TECH TIP

Product: DISPENSING VALVE – UF1 and UFB

Subject: REPLACEMENT BANJO VALVE FOR WATER AND SYRUP

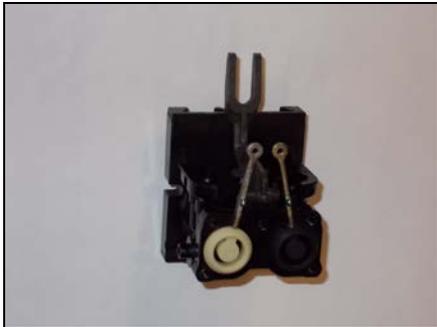
As part of the continuous improvement to our product lines, IMI Cornelius is updating the material selection of the “Banjo” valve to a more reliable and longer wearing material. The new parts are completely interchangeable with the old parts, and will not affect the operation of the valve.

Both water and syrup sides of the valve will now use a single component, **P/N 1947**.

- 1) **P/N 1947** (black) is the current part number, and looks identical to old **P/N 1947**.
- 2) **P/N 560003995** (white banjo) will be discontinued and replaced by **P/N 1947**.
